ADDENDUM # 1

PROJECT: P S J A I. S. D.
Carnahan, Franklin & Buell
HVAC Additions to Gyms
Bid # 18-19-052

ARCHITECT: EGV Architects, Inc.
220 S. Bridge
Hidalgo, TX 78557
(956) 843-2987

SHEET
AH1.0
1 OF 1

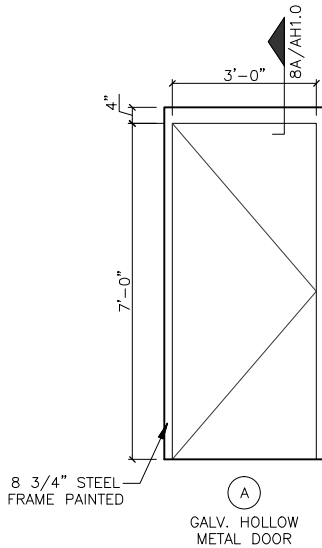
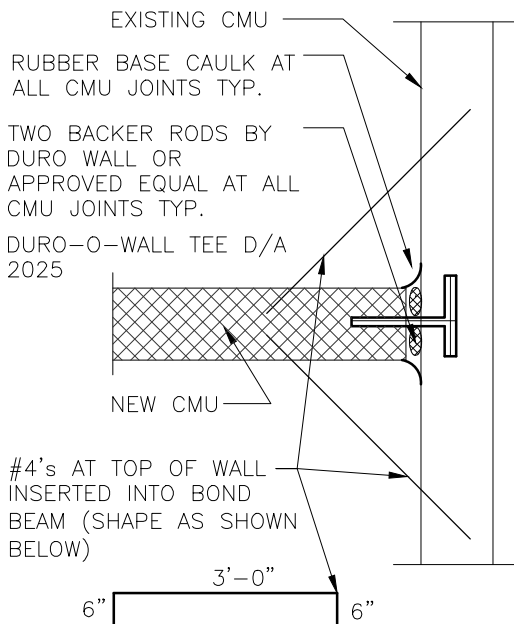
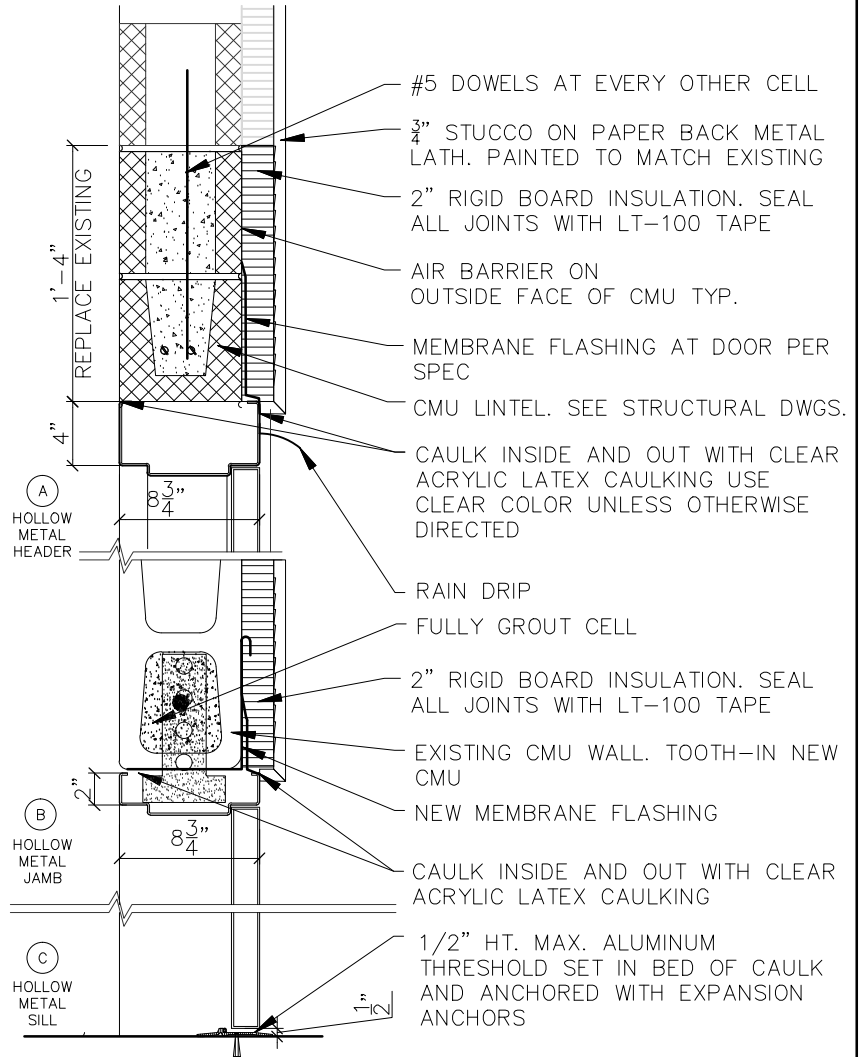
ITEM #10 Addition, Drawings Sheet AH1.0 Detail #1

- Add fire riser room per drawing labeled **ATTACHMENT #5** (1 page).
- Add new door detail & top of wall reinforcement per drawing labeled **ATTACHMENT #6** (1 page).
- Provide 6" reflective letters on riser room door to read: RISER ROOM

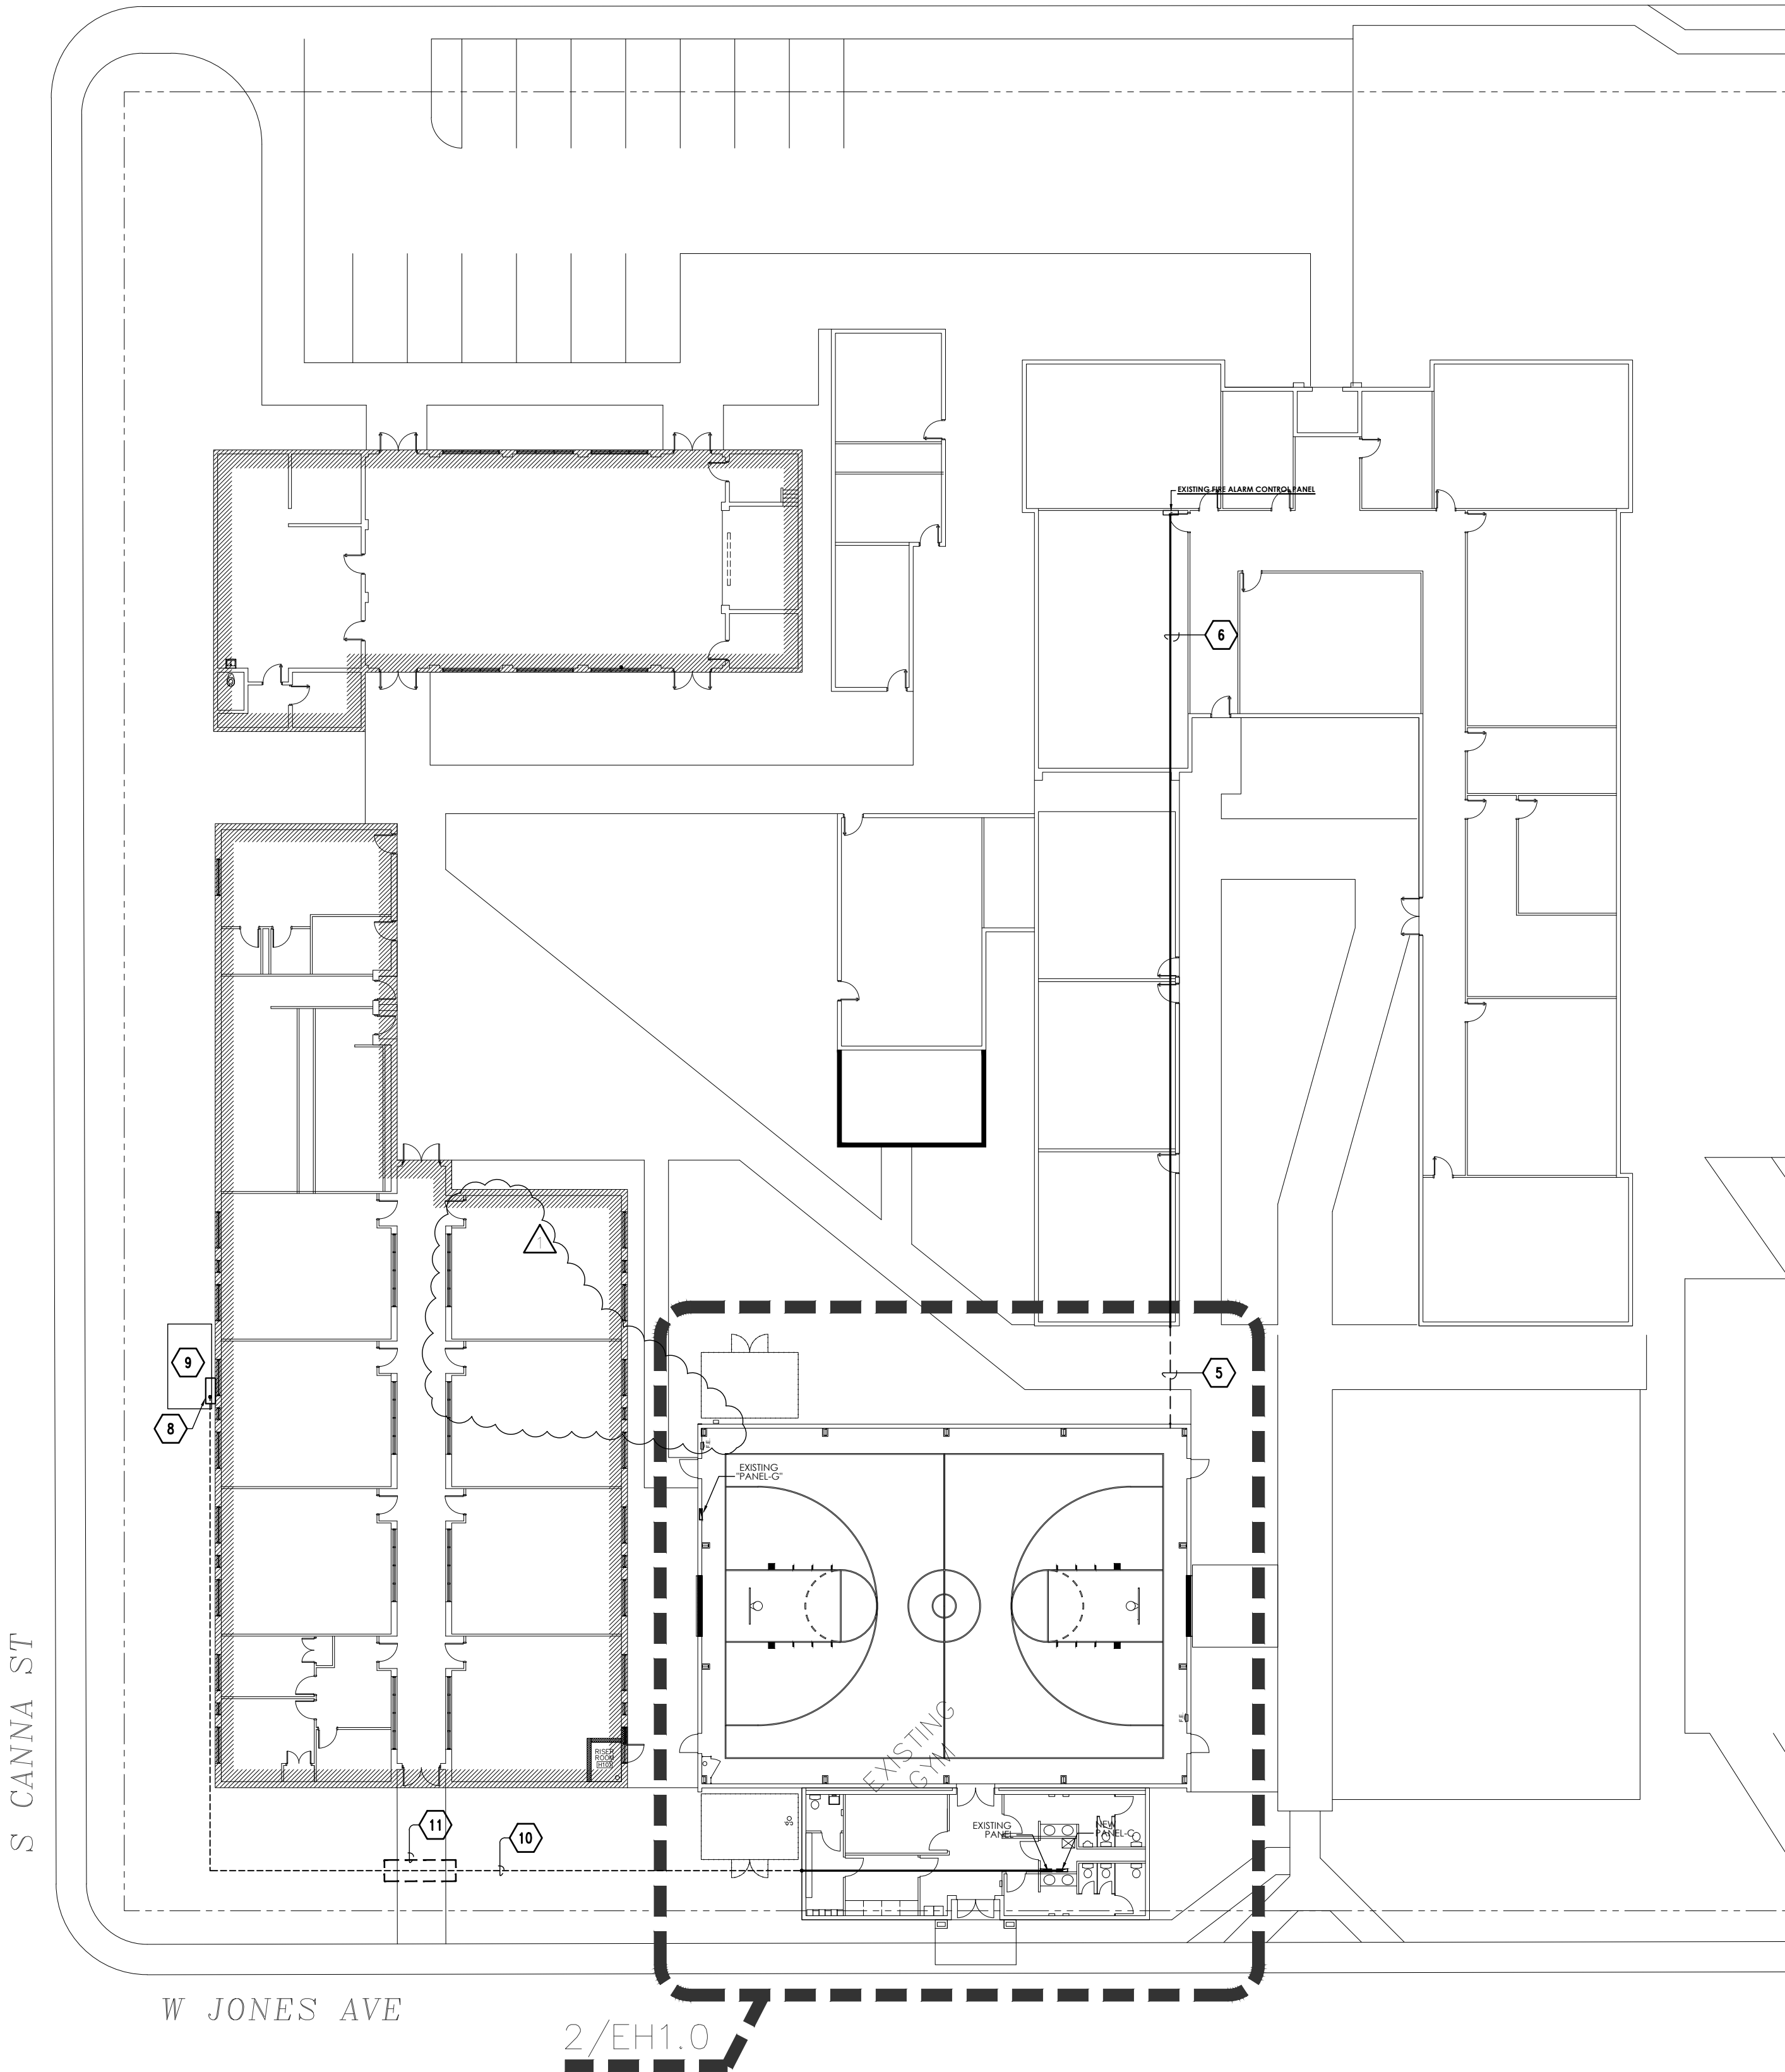
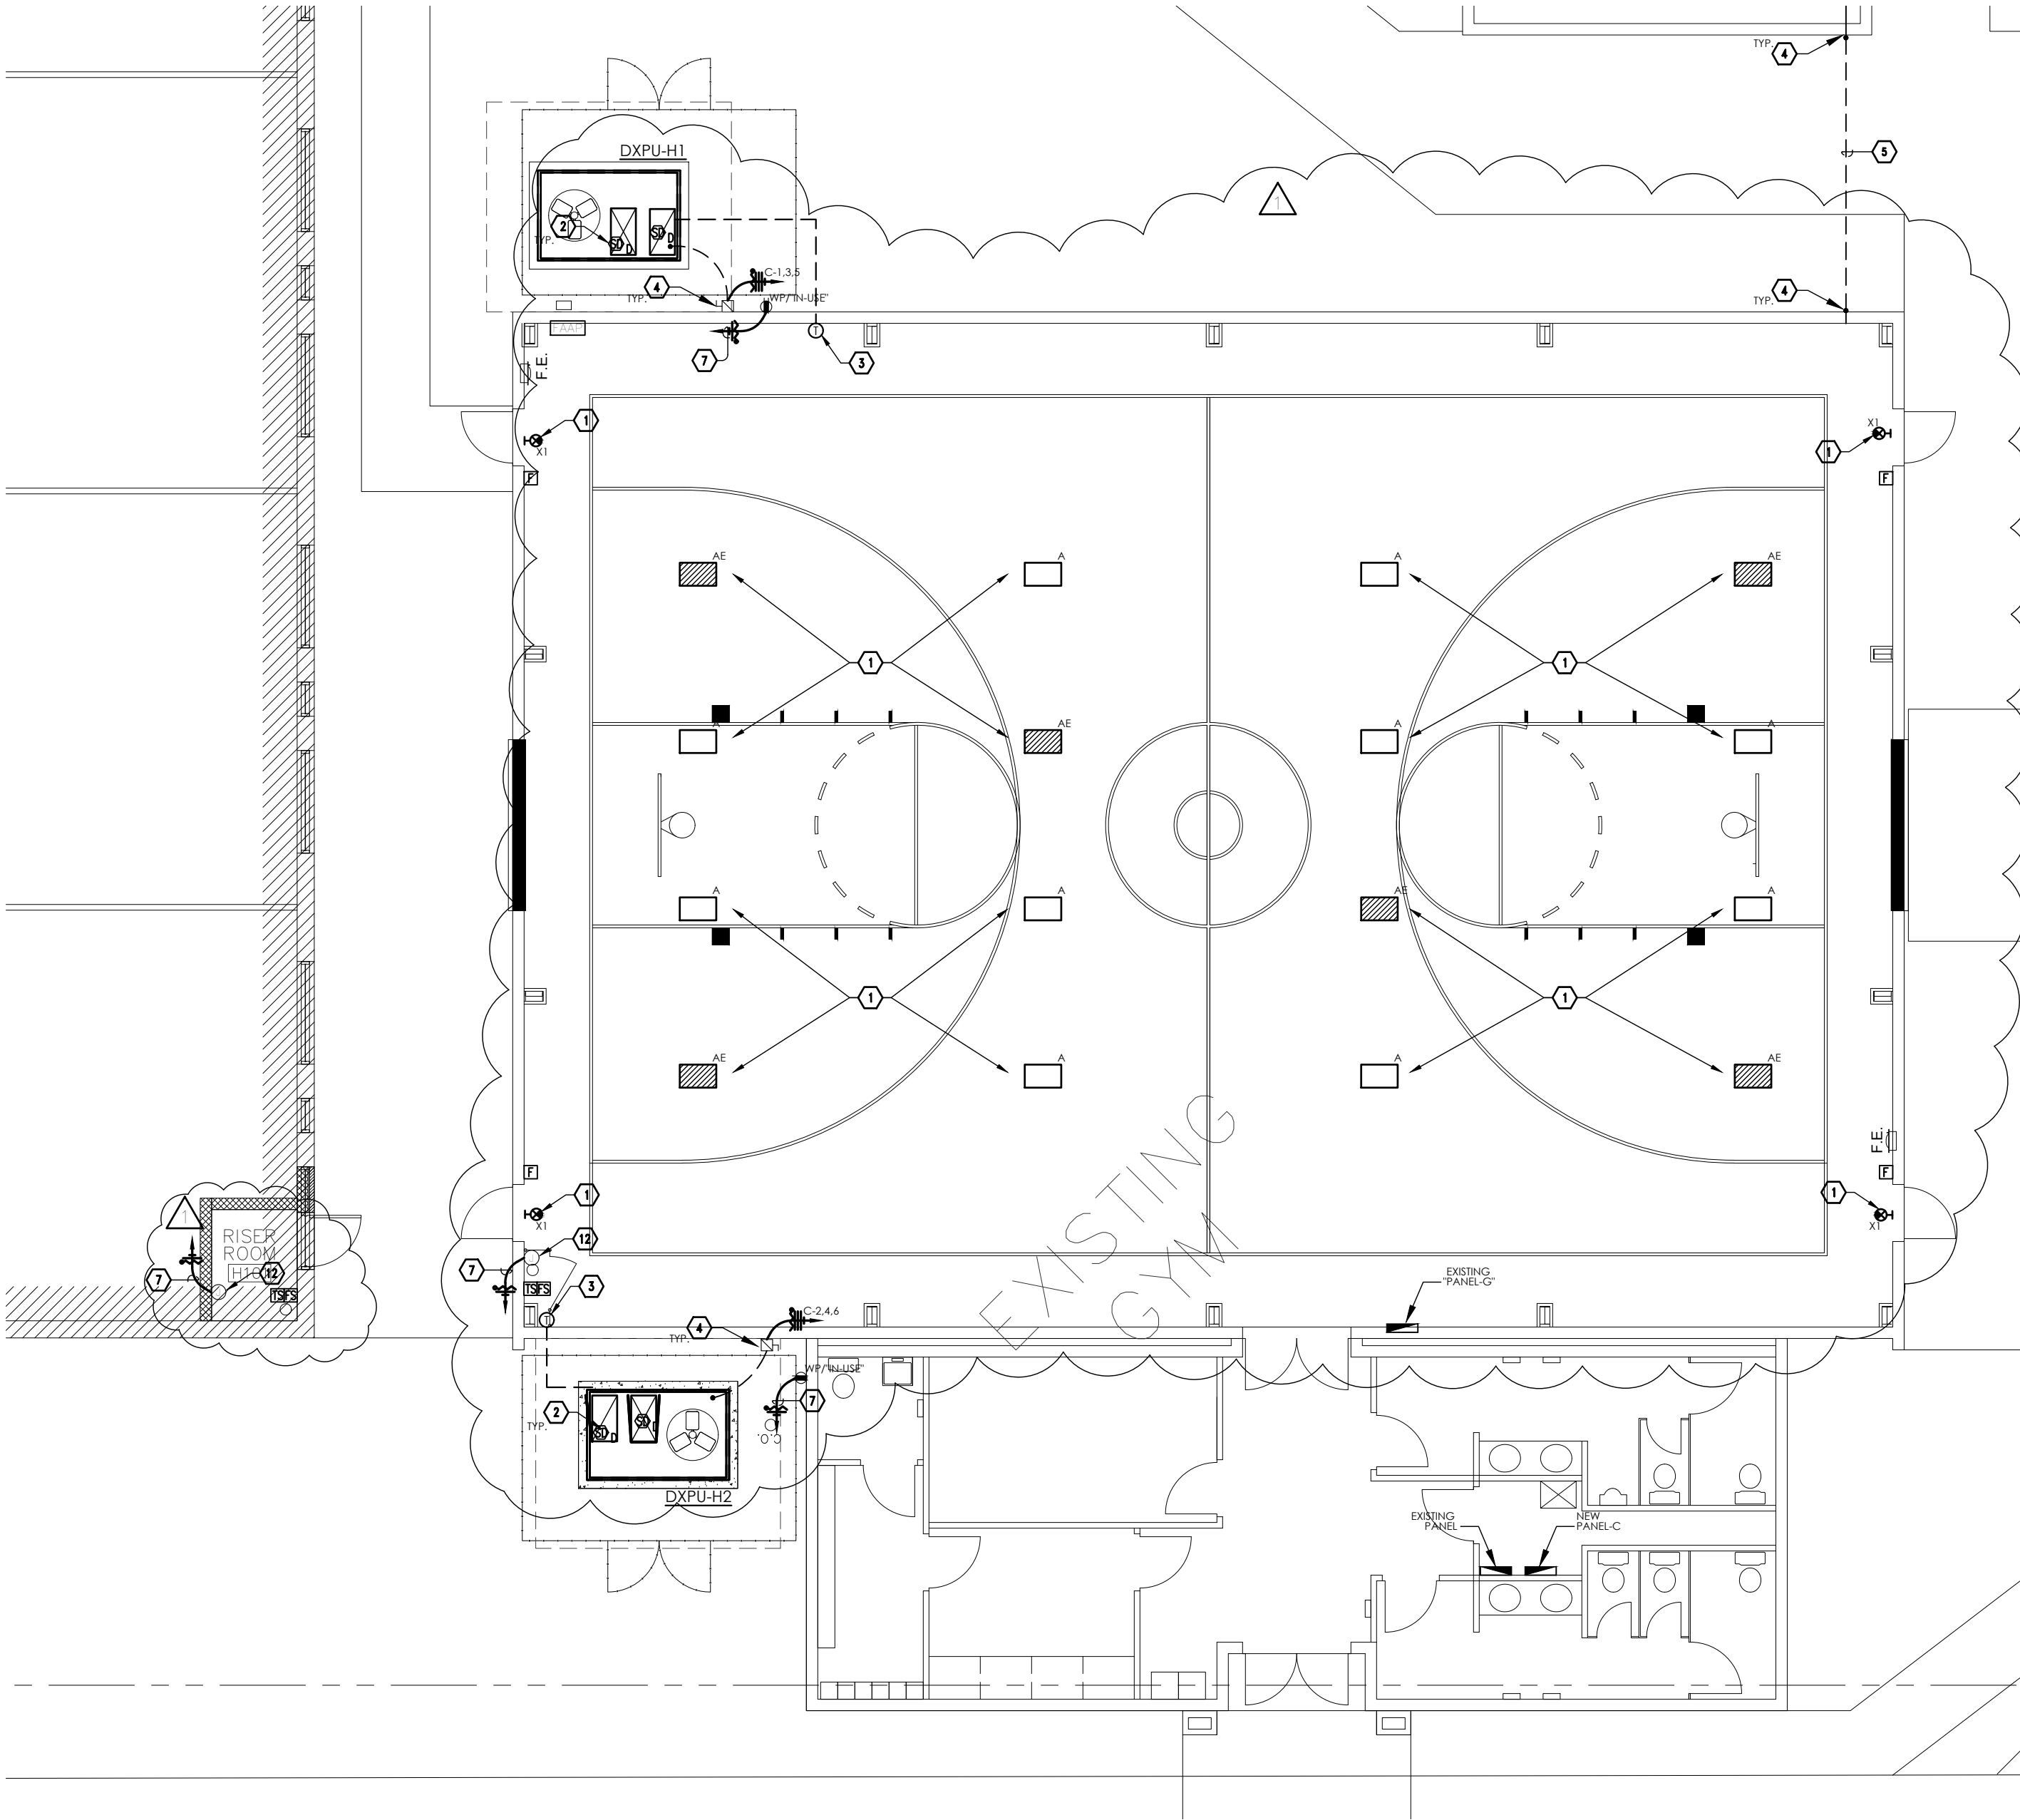
1. Sheet E0.0 – Revised Light fixture schedule.
2. Sheet EB1.0 – Revised plans refer to Addendum #1.
3. Sheet EB1.1 – Revised plans refer to Addendum #1.
4. Sheet EH1.1 – Revised plans refer to Addendum #1.
5. Sheet EI1.1 – Revised plans refer to Addendum #1.
6. Sheet E1.1 – Revised electrical riser and schedules. Refer to Addendum #1.
